- 5. Fritz Creek Drive Subdivision 2022 Addition**
KPB File 2022-093
Orion Surveys / Sorensen
Fitz Creek Area / Kachemak Bay APC

KPB File # 2022-093
S28 T05S R12W
Fritz Creek

ITEM 5 - FRITZ CREEK DRIVE SUBDIVISION 2022 ADDITION

KPB File No.	2022-093
Plat Committee Meeting:	July 18, 2022
Applicant / Owner:	NAME AND ADDRESS
Surveyor:	Tom Latimer / Orion Surveys
General Location:	Sorensen Street, Stuart Avenue, Fritz Creek / Kachemak Bay APC

FRITZ CREEK DRIVE SUBD. 2022 Addition

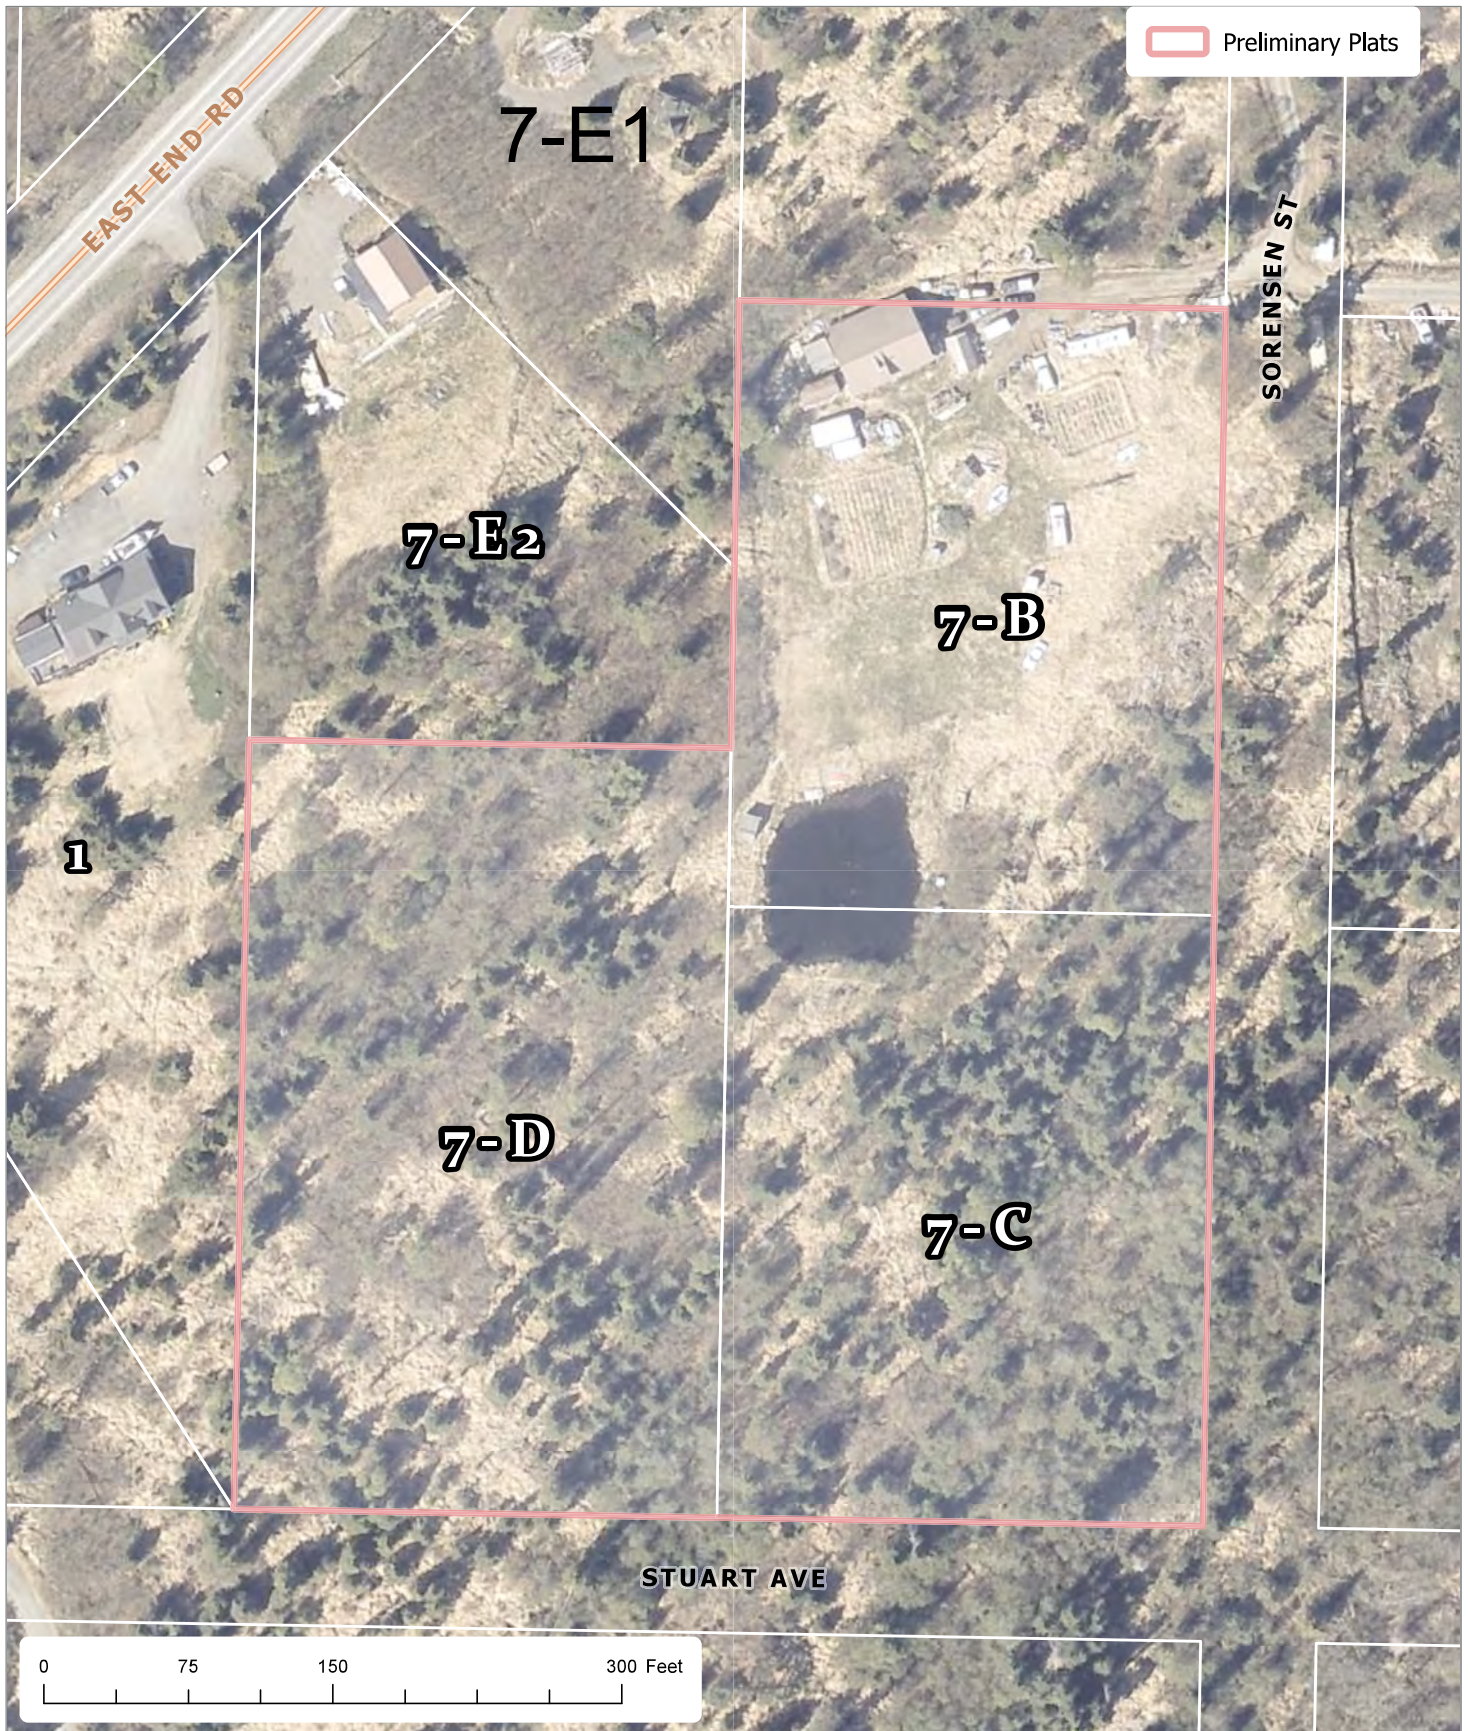
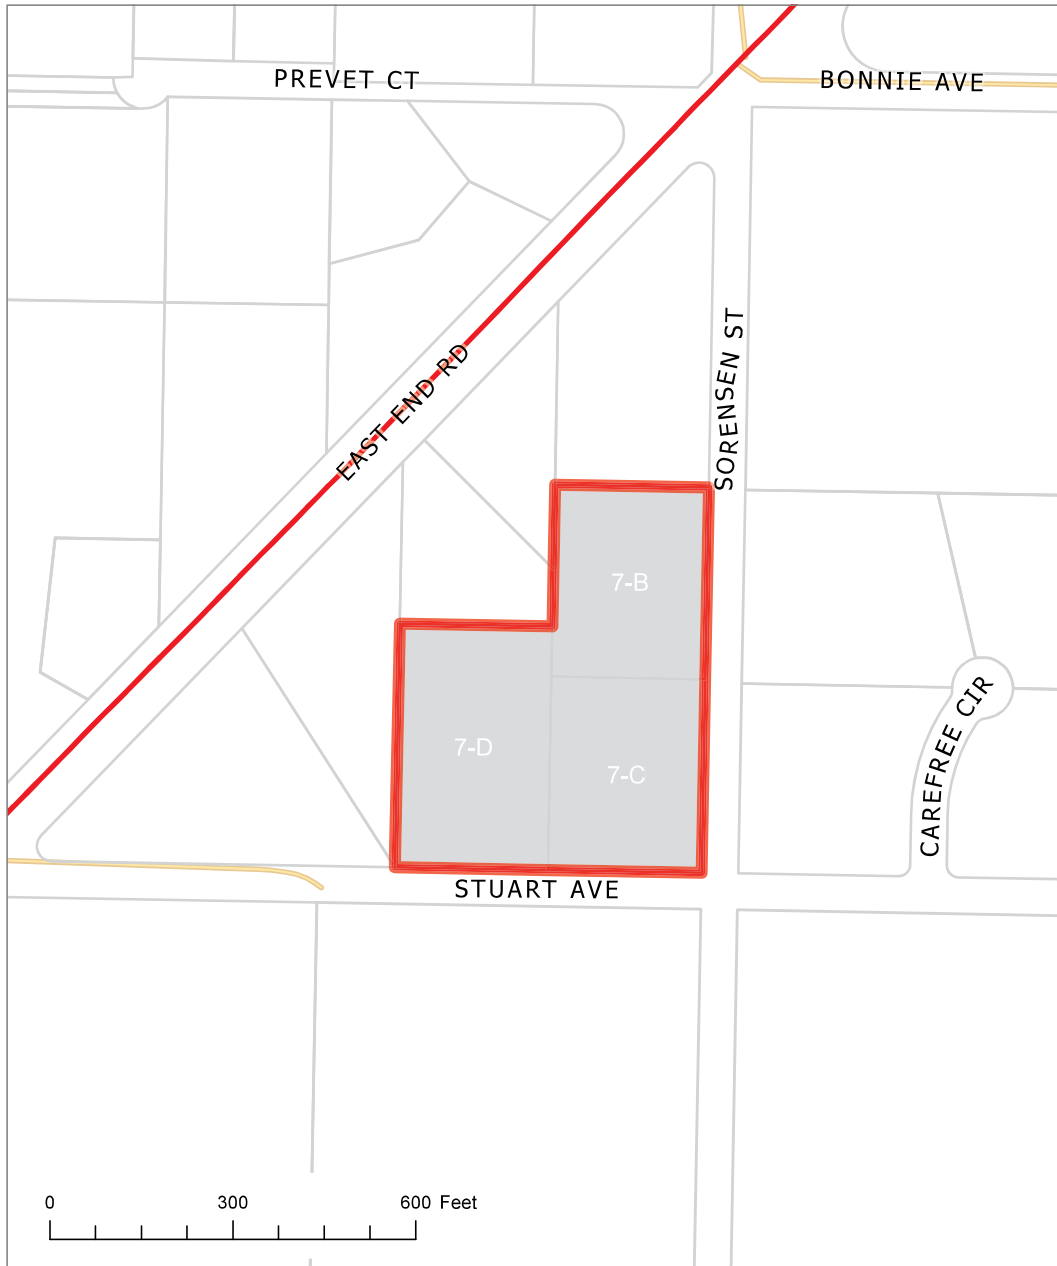
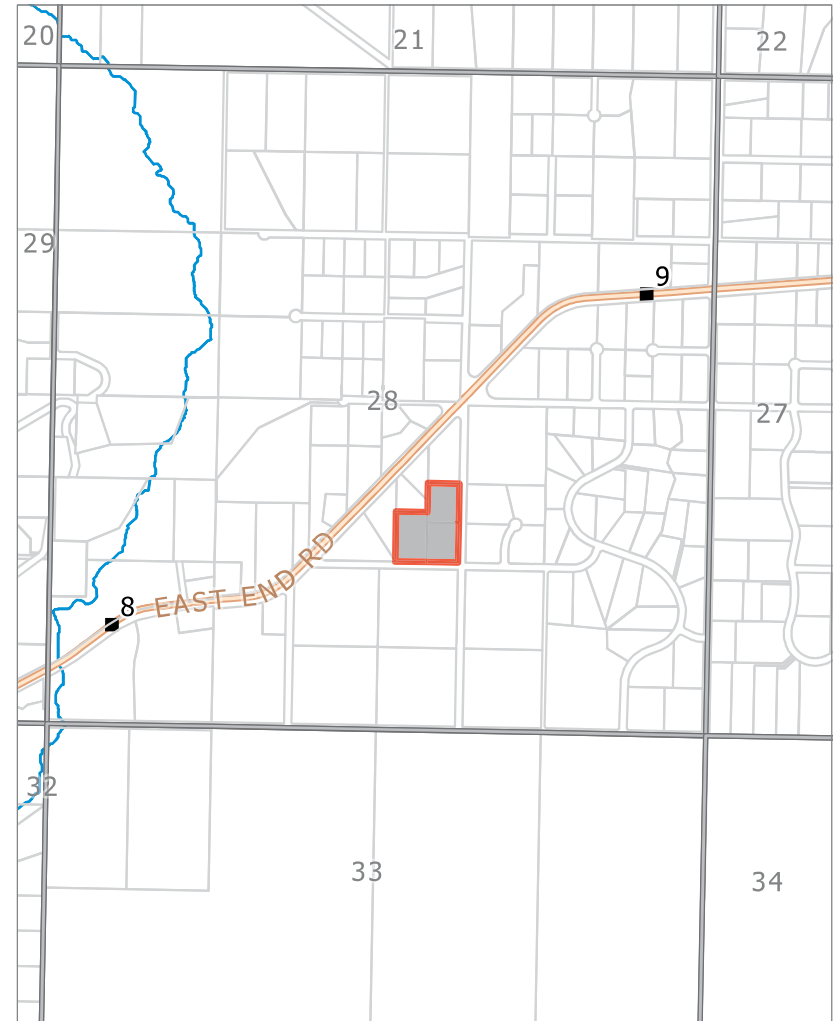
- C. The location, width, and name of existing or platted streets and public ways, railroad rights-of-way, and other important features such as section lines or political subdivisions or municipal corporation boundaries abutting the subdivision;
Staff recommendation: Correct the spelling of “Street” in the Sorensen Street label.

- G. The status of adjacent lands within 100 feet of the proposed subdivision boundary or the land status across from any dedicated rights-of-way that adjoin the propose subdivision boundary, including names of subdivisions, lot lines, block numbers, lot numbers, rights-of-way; or an indication that the adjacent land is not subdivided;
Staff recommendation: The East End Road depiction is outside the 100 foot requirement but if shown include a width label for that portion or a width varies label. Update the recording number for Lot 7-E2.

Staff recommendation: The preliminary was submitted in a scale of 1 inch is equal to 80 feet. A scale as outlined in code must be used. Comply with 20.60.070.

- Plat note 4 is not required as no dedications are occurring.
- Plat note 5 has a return that splits the note.
- Plat note 5 should include "Page" in the Book and Page description and include "No definite location disclosed" at the end of the note.
- Plat note 6, include a reference to KPB Code that allows no field survey to be performed, KPB 20.60.200(A).
- The wastewater note should remove "or a nominal 5 acres".
- Revise plat note 2. "A 5 foot clearing easement was granted by HM 74-2000 adjacent to Sorensen Street and Stuart Avenue. The 5 foot easement was carried over as a utility easement on HM 80-

Staff recommendation: The plat approval note needs to be updated to what is shown in KPB Code 20.60.190(C). Comply with 20.60.190.

Staff recommendation: Per KPB 20.60.200(A), a field survey is not required and is noted as such within plat note 6. The plat notes that all monumentation and information is from HM 80-101 and HM 2007-50. Staff requests that the information be noted from which plat the information is coming from. This can usually be accomplished by noting in the legend that information in parenthesis or brackets indicate which record source. Some surveyors prefer to assign a (R1) and (R2) that is noted which record each are from and then all information contains the notation of R1 or R2. Comply with 20.60.200
